AMENDMENT OF SOLICITATION/MODIFICATION OF CONTRACT			1. CONTRACT ID CODE	PAGE OF PAGES	
			J	1	2
2. AMENDMENT/MODIFICATION NO. 0003	3. EFFECTIVE DATE 16-Jul-2007	4. REQUISITION/PURCHASE REQ. NO.		5. PROJECT NO.(If applicable)

Pol-E-Charki Site Drainage Work

Attached file is provided to inform contractor of site drainage work currently being conducted within Pol-E-Charki ANA Brigade location.

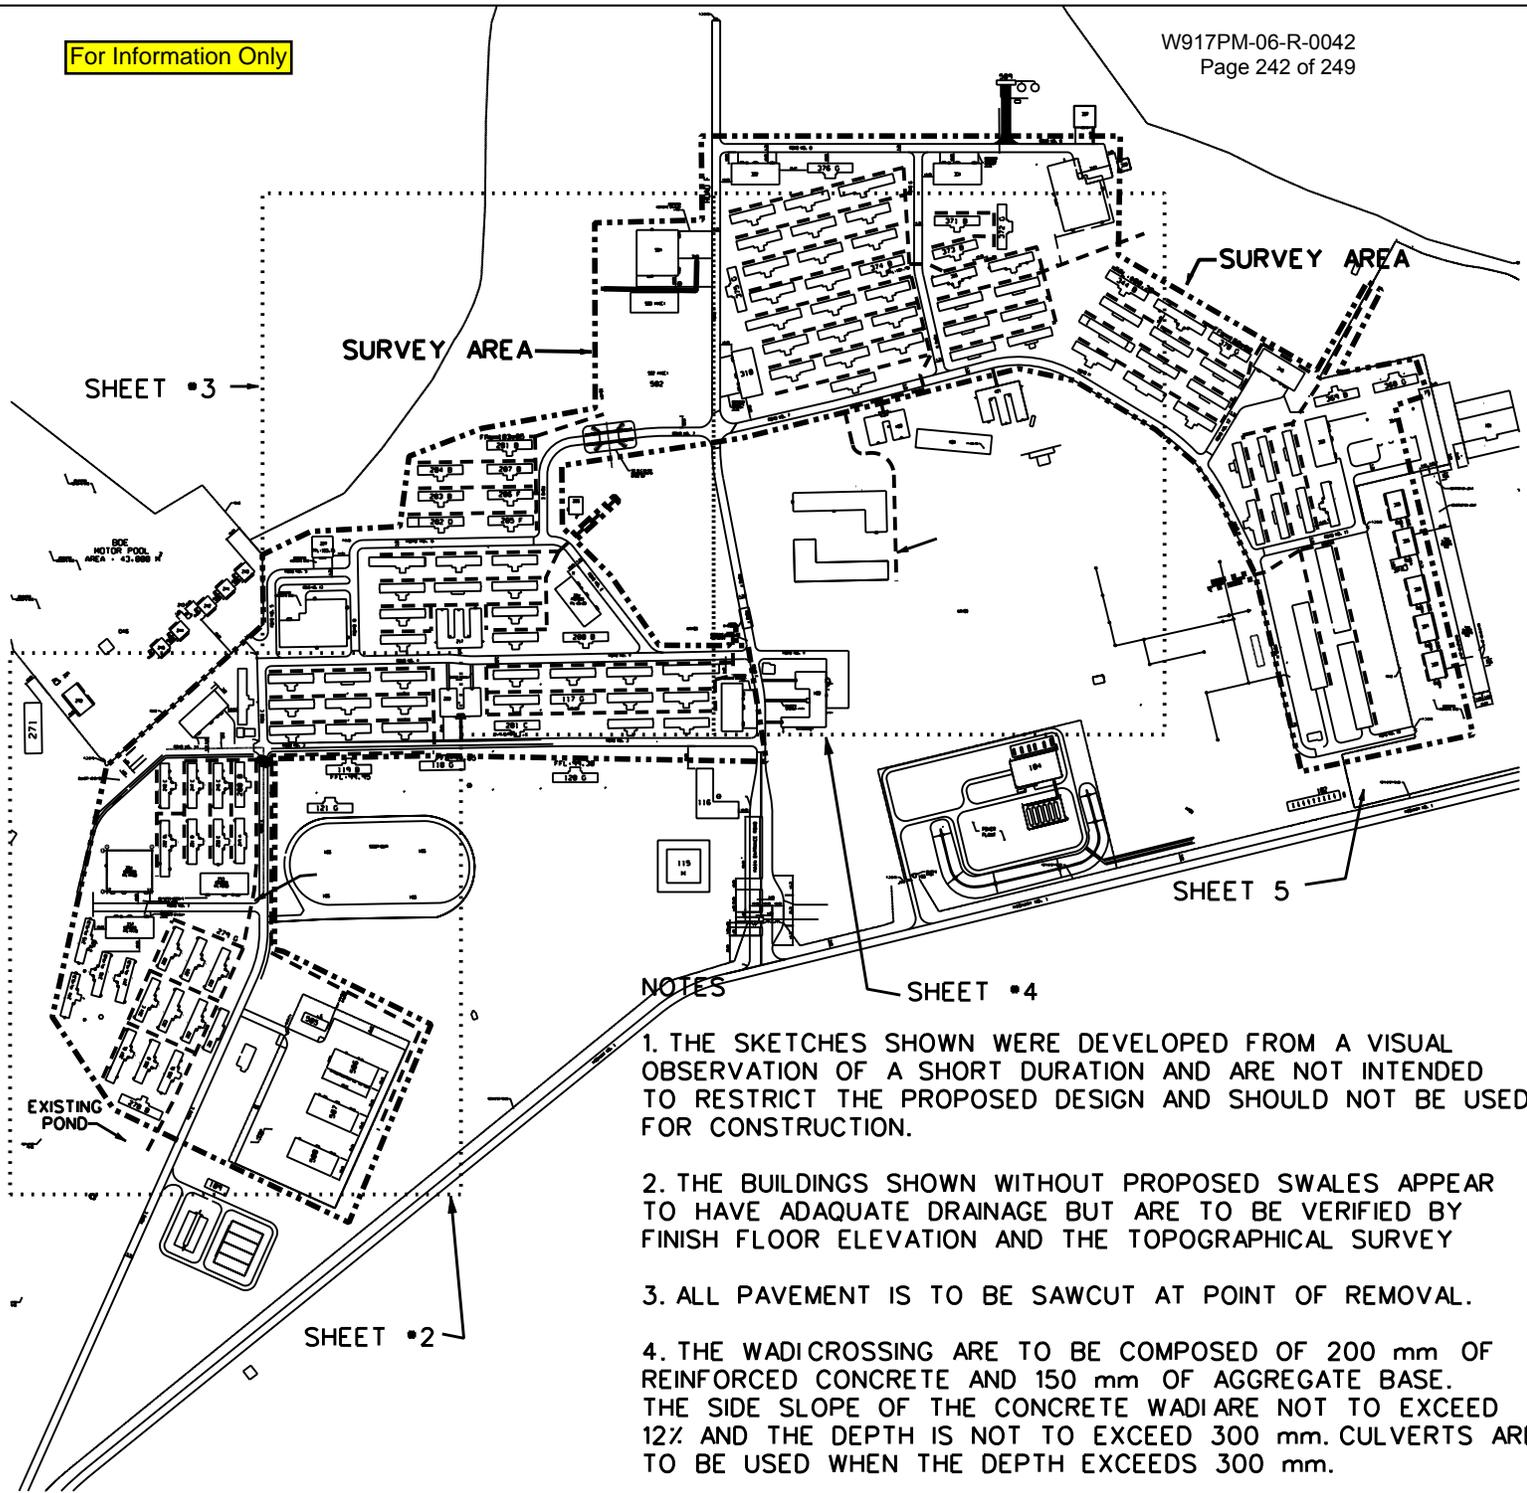
Question: We need your assist to get the following missing areas regarding the above subject project site. As per RFP documents and according to data sheet these buildings have nothing information about area, wall area, etc.

Answer: See attached file of the building areas of the Pole-E-Charki site.
